PRODUCT CHANGE NOTIFICATION

#PCN-DC-SK21-13

Business Unit	Product Line Code	Type of Change	Action	Date of issue
DC	AAA	Mechanical	Notify Distributors and Field	3/22/2013

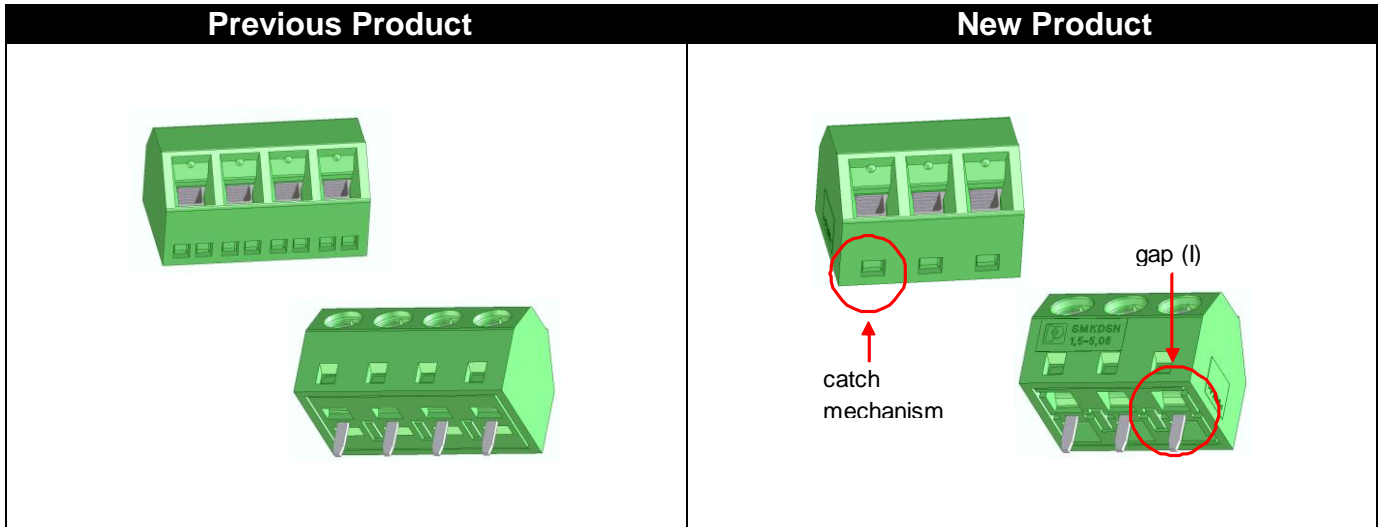
Due to our continuous improvement process the above mentioned articles will be delivered with a modified bottom plate as shown on the pictures. It will get additional gaps (I) and an optimized catch mechanism (II). Dimensions and technical data remain the same. During the conversion period both versions will be delivered depending on the inventory.
